**Subject:** LaSalle County Nuclear Power Station Units 1 and 2  
Application for Amendment of Facility Operating Licenses  
NPF-11 and NPF-18, Appendix A, Technical Specifications,  
Feedwater/Main Turbine Trip System Actuation  
Instrumentation Design Change.  
NRC Docket Nos. 50-373 and 50-374

**ATTACHMENT A**  
**DESCRIPTION OF SAFETY ANALYSIS OF THE PROPOSED CHANGES**

This proposed license amendment will change Technical Specification (TS) 3/4.3.8, Feedwater/Main Turbine Trip System Actuation Instrumentation, due to a design change to resolve a potential instrument line redundancy issue concerning the Reactor Vessel Water Level-High, Level 8, Trip Function. The actuation logic currently consists of three instruments with auxiliary relay contacts arranged in a two out of three trip logic. Therefore, when high reactor water level is sensed by any two of the three level instruments, an actuation signal is generated to trip the Feedwater Pumps and the Main Turbine.

LEVEL TRANSMITTER PIPING CONFIGURATION

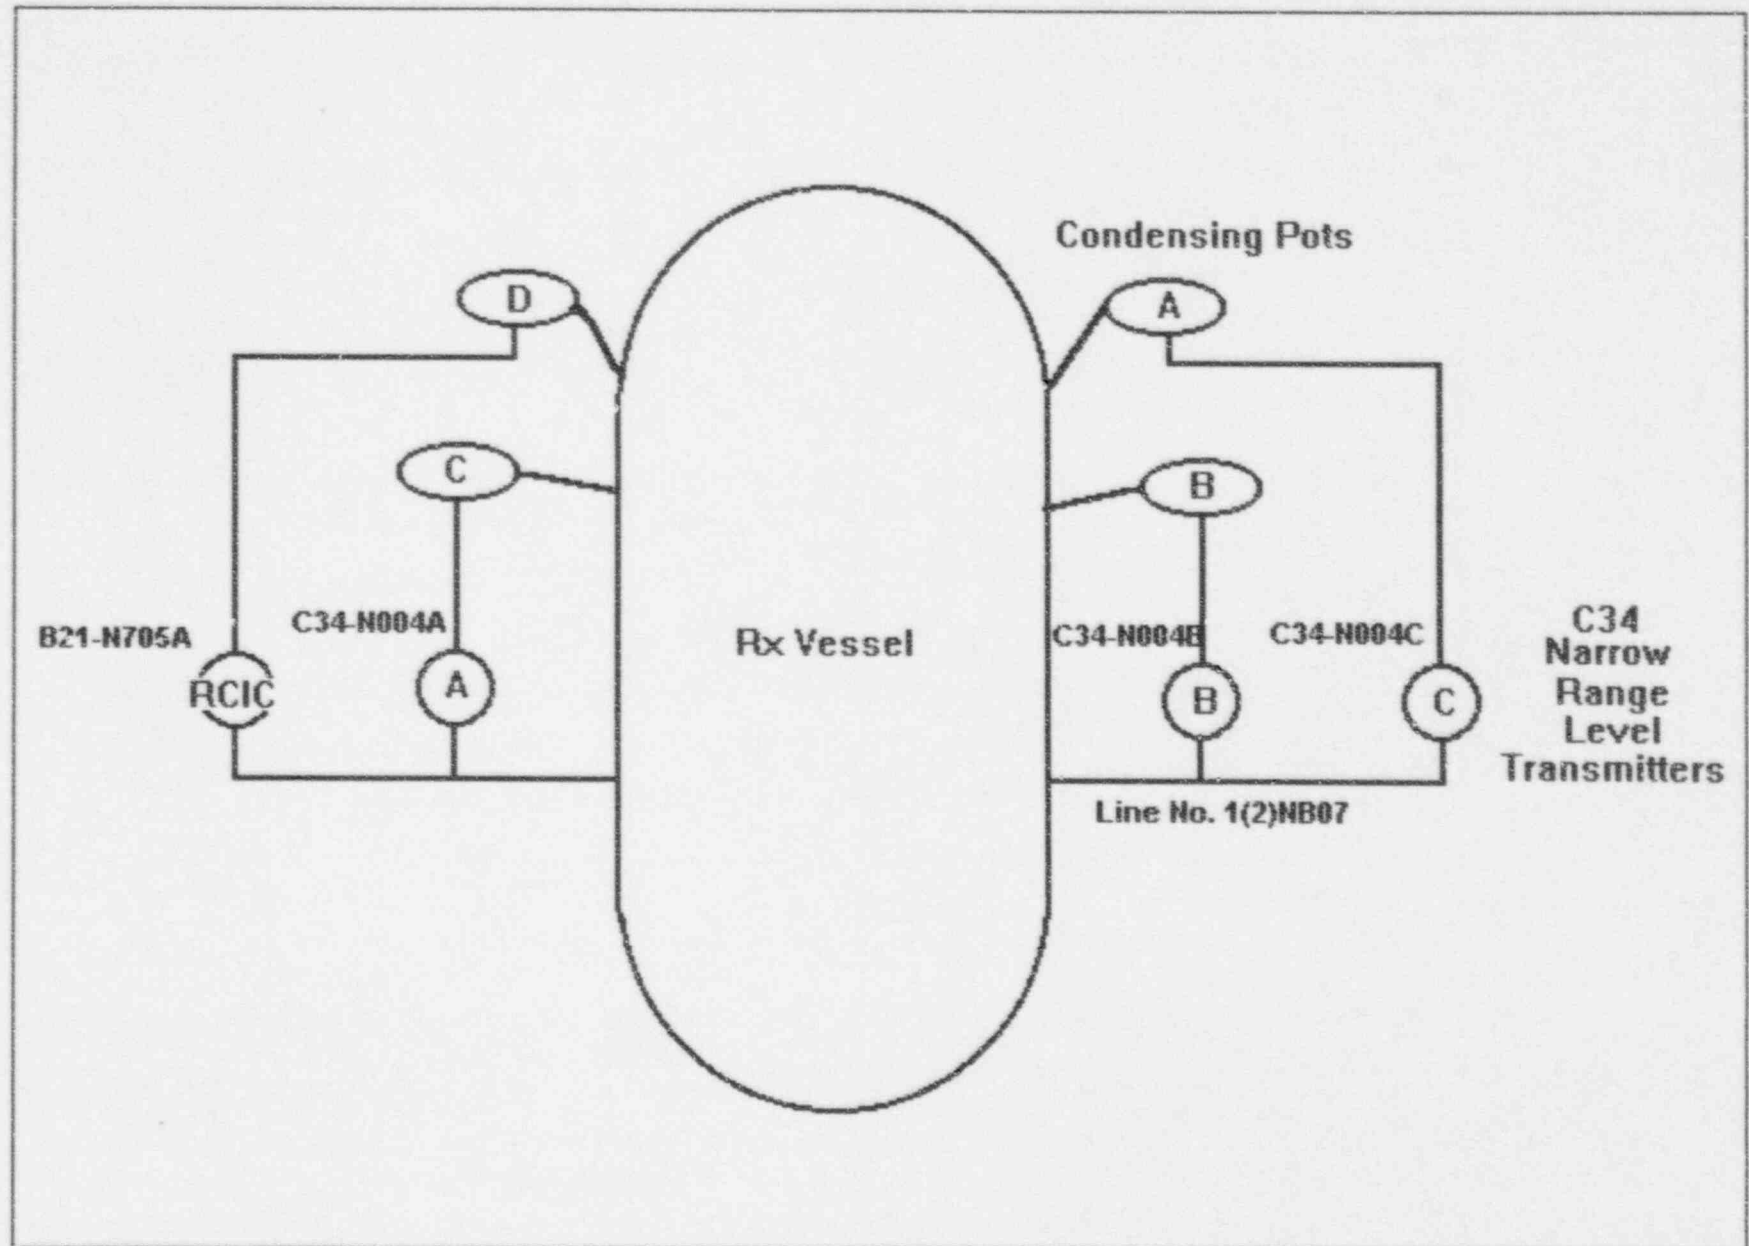
The level 8 trip utilizes three level signals to perform a trip function with 2 out of 3 logic. Even though the system is not divisionally separated, it still uses a separate power source for each water level signal and trip initiation circuit such that the loss of power to one trip signal will not prevent the trip from occurring. However, during a system design review for replacing the Reactor Water Level Control (RWLC) reactor water level instrument channel selector switch, it was identified that the loss of a single instrument variable water leg instrument line (line number 1(2)NB07) would result in the loss of the level 8 trip function due to reactor vessel narrow range water level transmitters 1(2)C34-N004B and 1(2)C34-N004C failing downscale. This failure would disable channels B and C of the Reactor Vessel Water Level-High, Level 8 trip logic of the Feedwater/Main Turbine Trip System Actuation Instrumentation. Figure 1 is a simplified diagram showing the high water level trip instrumentation.

A design change is being installed to add an additional high level trip signal from a separate sensor to the Feedwater/Main Turbine trip logic, while preserving the two out of three actuation logic. The added sensor will prevent the failure or loss of a single instrument variable water leg instrument line from preventing a Feedwater/Main Turbine trip system actuation on actual high reactor water level.

SIMPLIFIED LEVEL 8 TRIP ACTUATION LOGIC  
CURRENT CONFIGURATION

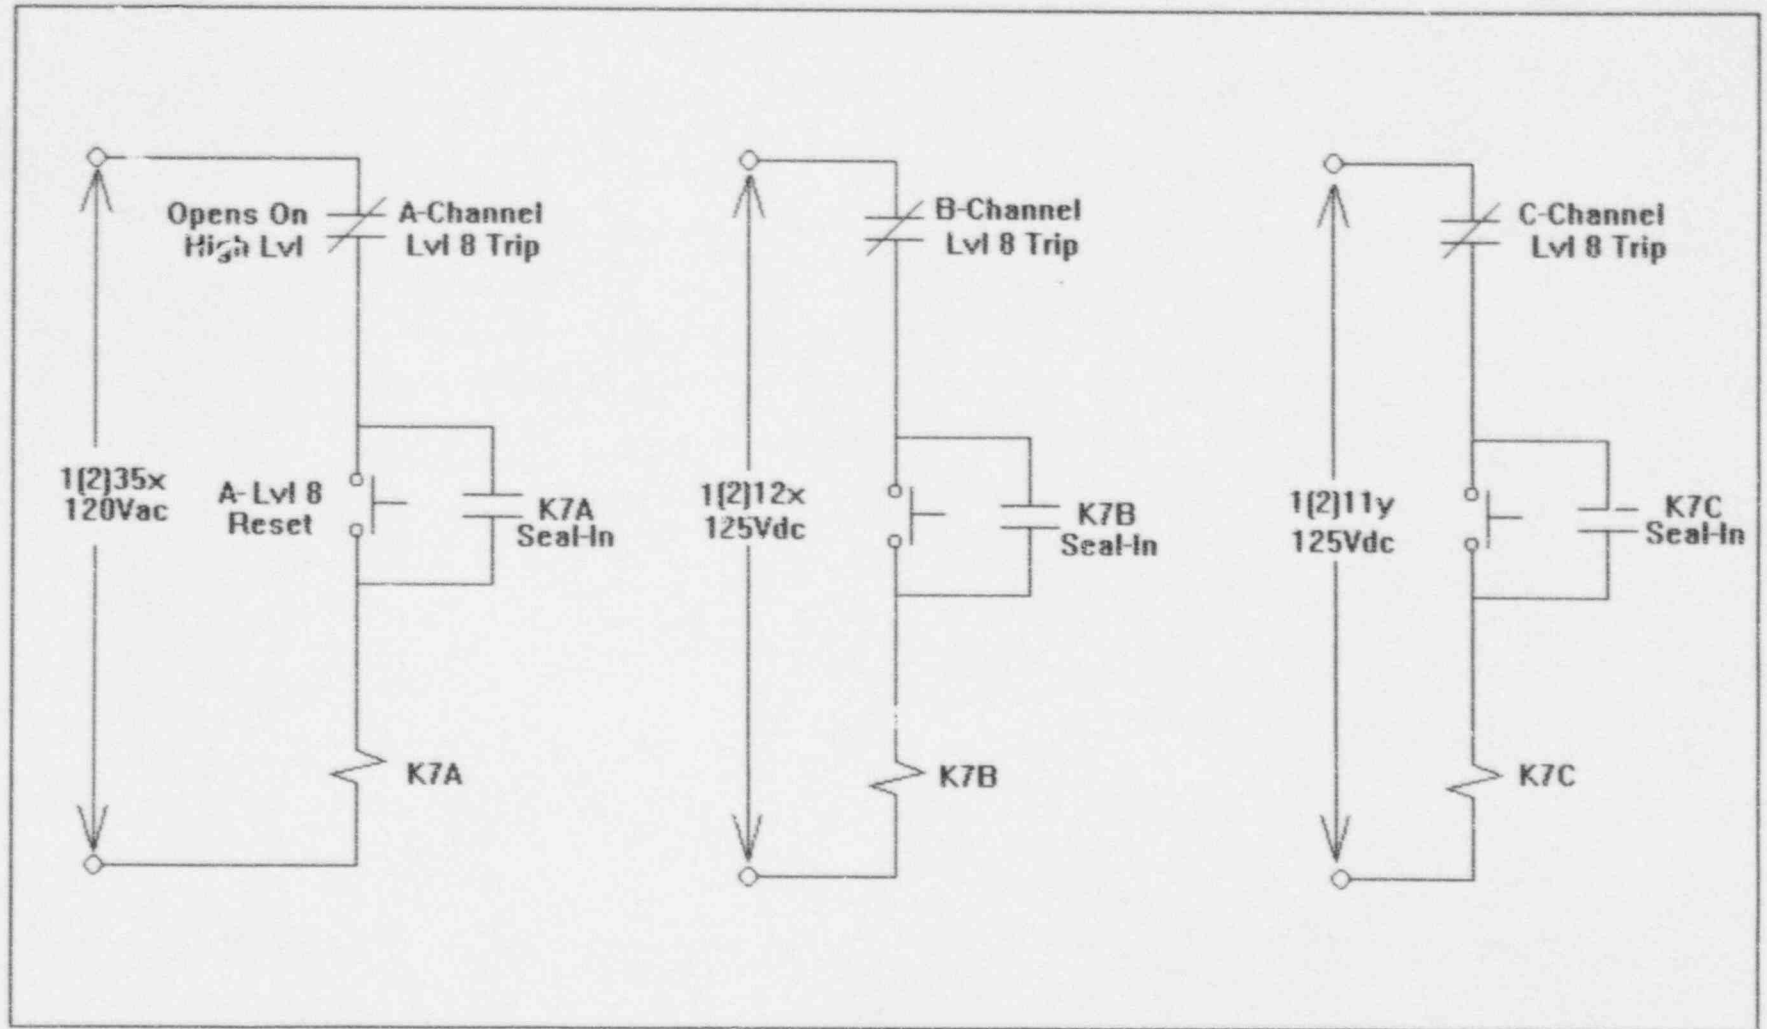
The trip system is not designed to any applicable IEEE standards, Reg Guides or 10CFR50 Appendix A General Design Criteria per UFSAR Table 7.1-2, "Codes and Standards Applicability Matrix". The trip system is not required nor designed to meet single failure criteria. This is a non-safety/non-divisional trip actuation, which is required in Operational Condition 1, Run Mode, by Technical Specification 3/4.3.8 such that high integrity is maintained. The current channel and trip system logic is depicted in Figures 2 and 4, attached.

The original Feedwater/Main Turbine trip on high reactor water level consisted of three channels, channels A, B, and C, actuated by three reactor water high level 8 trip units, C34-K624A, B, and C, respectively. The differential pressure (level) transmitters are C34-N004A, B, and C, respectively. The design change adds the A channel (Division 1) of RCIC Reactor Water Level-High, Level 8, signal to the Feedwater/Main Turbine Reactor Water Level-High, Level 8, trip logic channel C using a spare contact of auxiliary relay B21-K705AX.

MODIFIED LEVEL 8 TRIP ACTUATION CIRCUIT  
(Addition of RCIC Division 1 Level 8 Trip Channel)

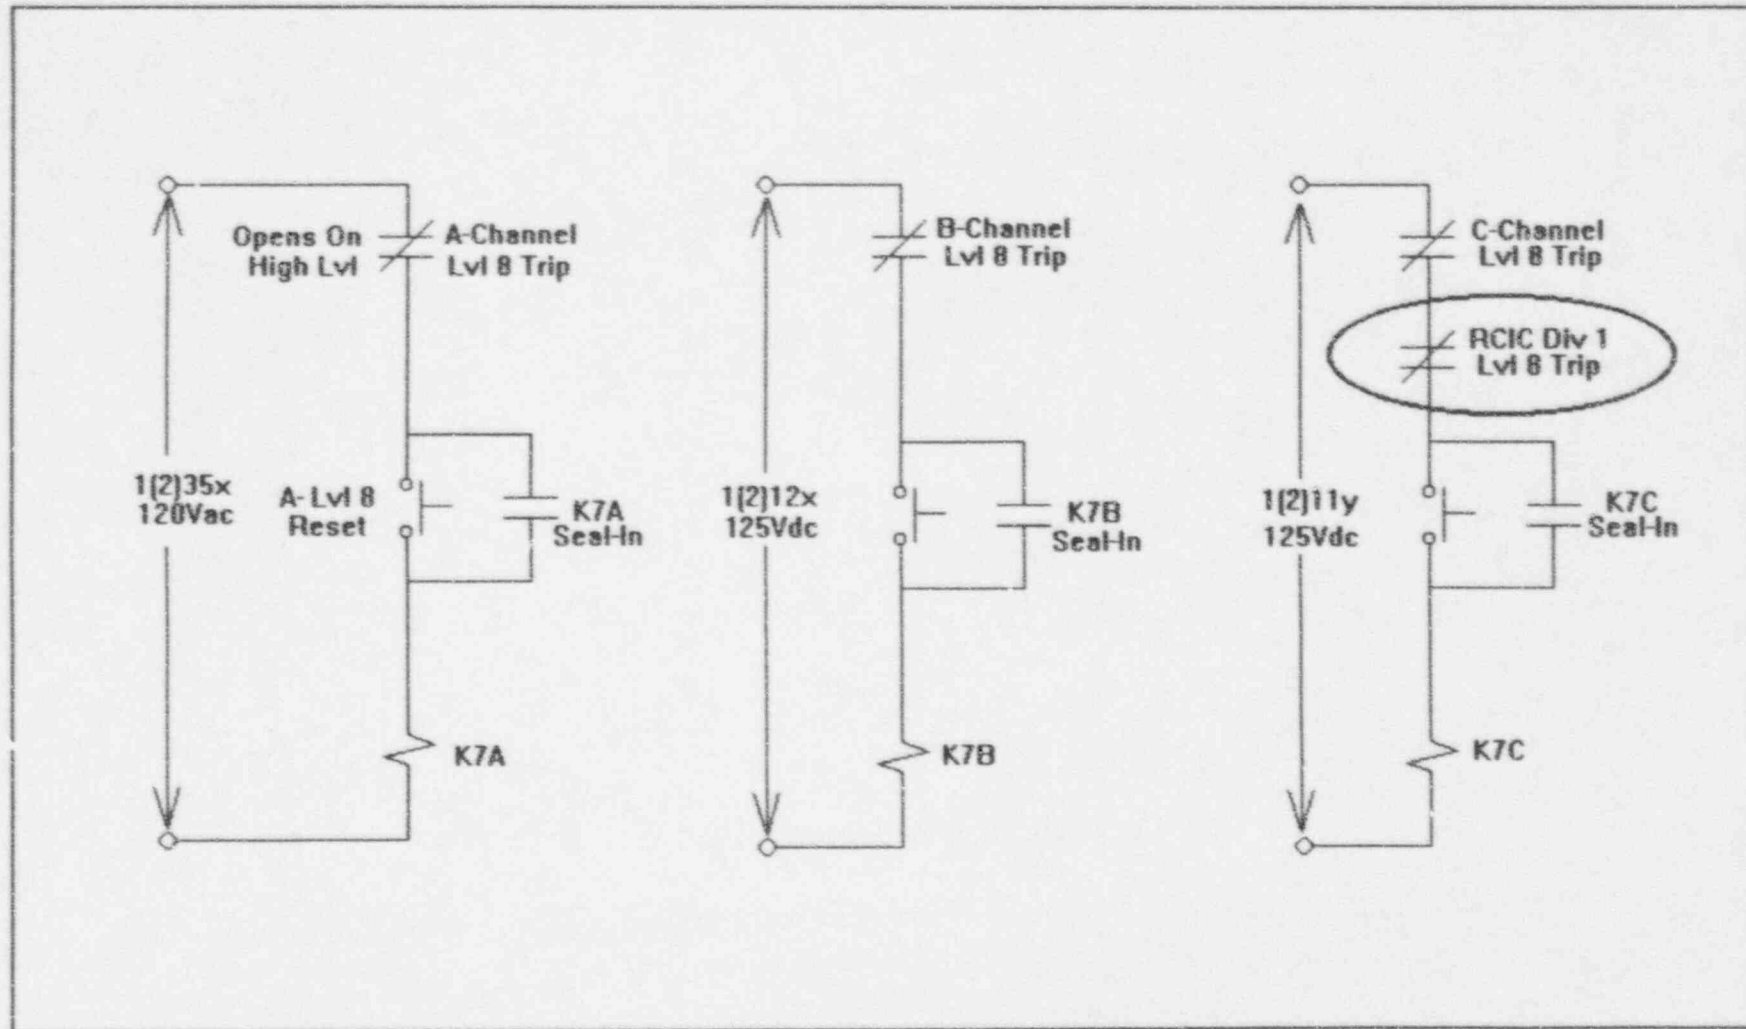
The four instrument channels are arranged to make a two out of three trip logic (see Figures 3 and 4). The two out of three logic depicted in Figure 4 is not changed by this design change. In order to eliminate the loss of the Reactor Vessel Water Level-

High, Level 8, trip due to the loss of either variable water leg instrument line for narrow range level instrumentation, trip channel C of the level 8 trip logic contains two high reactor vessel water level (level 8) sensor trip relay contacts. Therefore, trip channel C contains two instrument channels, providing the redundancy needed to prevent a failure to trip of the Feedwater Pumps/Main Turbine due to an instrument line failure. One of the four channels (one of the two channels in trip channel C) is from the Channel A RCIC high reactor vessel water level (level 8) trip relay, which is required to be Operable per LCO 3.3.5, Reactor Core Isolation Cooling System Actuation Instrumentation.

The use of a spare contact from the RCIC high water level trip auxiliary relay assures the two logics are electrically isolated from each other. As a result, the failure of the logic for either RCIC or Feedwater/Main Turbine trip on high reactor water level will not affect the other system's logic. Also, the power supplies for RCIC Channel A and Feedwater/Main Turbine Channel C are the same electrical division and both are 125 VDC.
